Application for "Other Business" Cobb County, Georgia

Application for Special Land Use Permit Cobb County, Georgia

Application No.: SLUP-3 (2004)
Hearing Dates: February 3, 2004 and
February 17, 2004

SITE & UTILITY PLAN

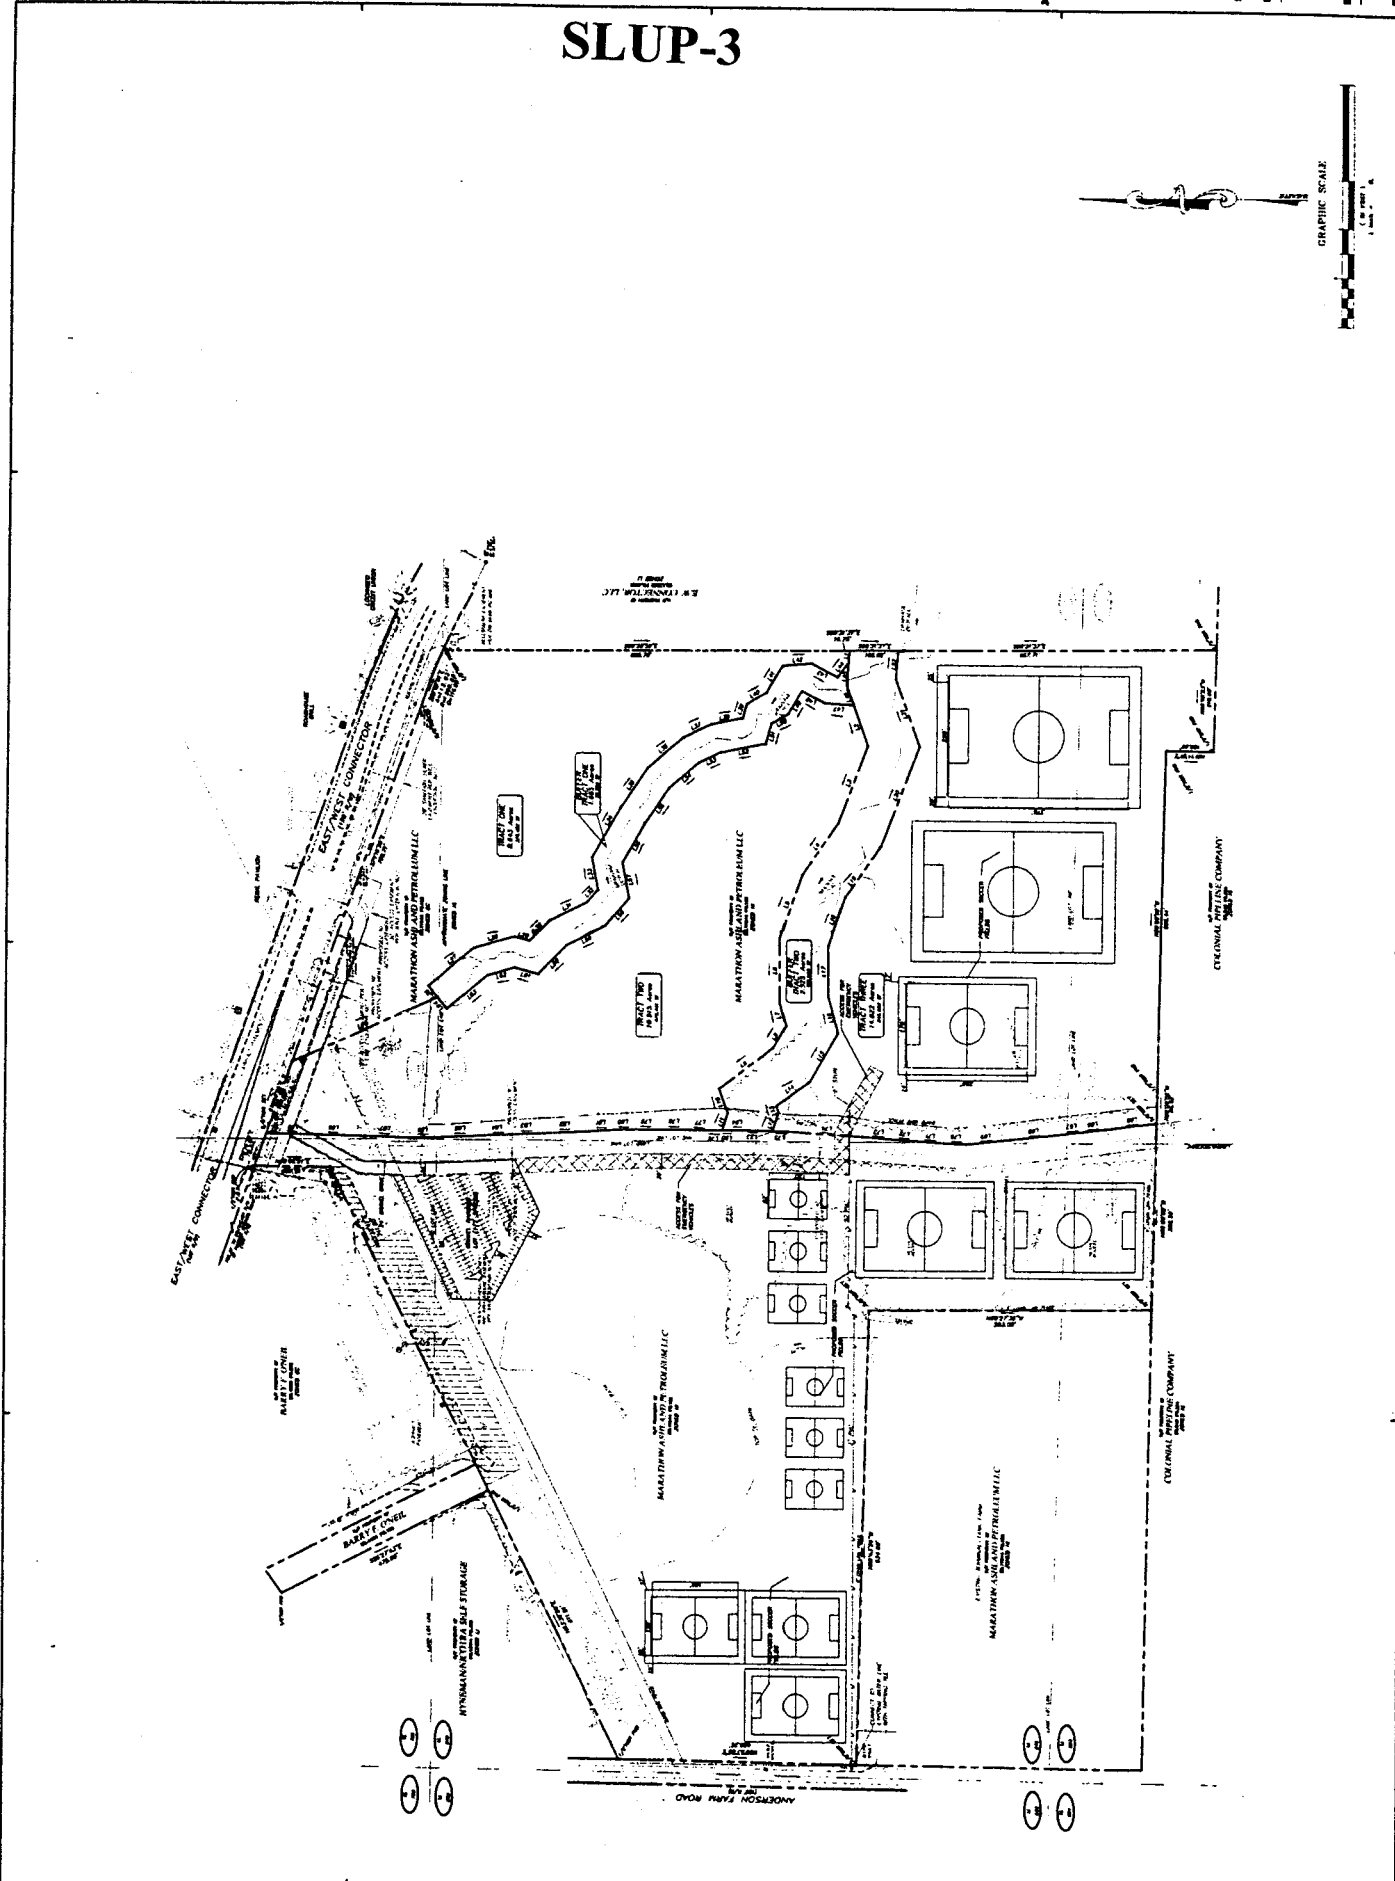
- Provide comprehensive hydrology/stormwater controls to include development of out parcels.
- Submit all proposed site improvements to Plan Review.
- Any **spring activity** uncovered must be addressed by a qualified geotechnical engineer (PE).
- Structural fill _____ must be placed under the direction of a qualified registered Georgia geotechnical engineer (PE).
- Existing facility.
- Project must comply with the Water Quality requirements of the CWA-NPDES-NPS Permit and County Water Quality Ordinance.
- Water Quality/Quantity contributions of the existing lake/pond on site must be continued as baseline conditions into proposed project.
- Calculate and provide % impervious of project site.
- Revisit design, reduce pavement area to reduce runoff and pollution.

- No Stormwater controls shown **must be addressed at Plan Review**.
- Copy of survey is not current - Additional comments may be forthcoming when current site conditions are exposed.
- No site improvements showing on exhibit.

- 1) Properties drain to streams and lake. Each is encumbered by stream buffer of 50 feet each side. This includes the lake buffer which is not shown. The proposed parking and fields encroach into the buffers. Stormwater Management cannot support the diminishment of the buffer contribution.

- 2) Manicuring these fields will require a high level of maintenance and supporting chemicals. This will form a major contribution to pollution of stream if not managed. At Plan Review the applicant must submit a written operation plan in line with United State-Clean Water Act guidelines to Stormwater Management (stop irrigation before runoff occurs, use liquid fertilizer only in dry window three days after and three days before rainfall, maintain tall grass on all down slopes, etc.)

- 3) Without sanitary sewer available, installation of any septic tank field must be at least 100 liner feet away from any water course. With the Health Department blessing, the fields needs to be much longer than normal to reduce soil loading.

- 4) Recommend predesign meeting with Stormwater Management to review preliminary grading plan and preliminary operation plan.

- Site plan received by the Zoning Division December 4, 2003, with the District Commissioner approving minor modifications to site layout;
- Water and Sewer comments and recommendations;
- Stormwater Management comments; and
- DOT comments and recommendations.
